RotorSport UK Ltd

Service Bulletin

SB No.: 036 issue 1	CCAR No.: None	Classification: OPTIONAL or RECOMMENDED or MANDATORY
Aircraft type & model (applicability) RotorSport UK MT-03and MTOsport series	Aircraft serial Nos. effected RSUK/MT-03/all RSUK/MTOsport all

Insulator pad in place but not finished

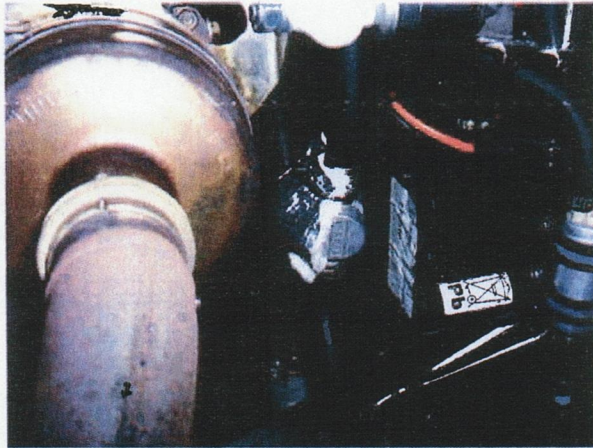
A simple modification is now available that will increase the oil temperature by preventing the radiant heat from the exhaust system affecting the operation of the oil thermostat. The modification consists of a pad of fire-resistant insulator, a length of locking wire and a length of foil tape for cosmetic finishing. It is available as field-service kit RSD4564 and may be fitted by the Pilot or by a CAA BCAR A3-7 Authorised Person

- 1) Using a proprietary solvent (e.g. white spirit or Amberklene LO30) and a rag clean the thermostat body of any oil residue or debris.
- 2) Remove the backing material from the pad to expose the self-adhesive layer. Place the pad centrally on the thermostat between it and the exhaust silencer with the offset holes correctly positioned in-line with the gap between the oil pipes. Hand-form the pad around the thermostat body then pass the locking wire through the holes, between the oil-pipes then around the thermostat body (Note the split hose protecting the rear of the thermostat). Tension the wire so that the pad is secure but not crushed and twist the wire-ends in the normal way.
- 3) Use the self-adhesive foil tape to close the open ends of the pad and make a neat presentation of the installation, keeping the wire-lock twist in view.
